RE: Jim Reimer II 8621 Glendale NE Grading & Drainage Plan Engineer's Stamp Date: 4/21/25 Hydrology File: B20D022 Case # HYDR-2025-00138

Based upon the information provided in your submittal received 4/21/2025, the Grading & Drainage Plan **is not approved** for Building Permit. The following comments need to be addressed for approval of the above referenced project.

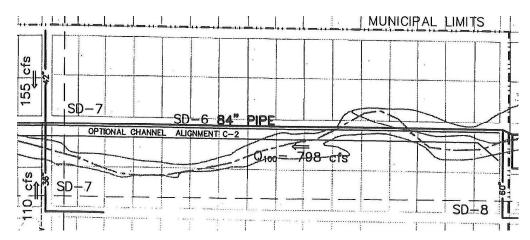
1. Per the IDO, the property owner of the property is responsible for building the adjacent half of Glendale Ave. NE to include curb & gutter, and sidewalk. The project will have to go to the Development Facilitation Team (DFT) / Delvelopment Hearing Officer (DHO) for approval of the Infrastructure List and re-platting action. Also, half of an 84" storm sewer (see below) will also need to added to the Infrastructure List. The storm sewer was called out in the NAA MDP.
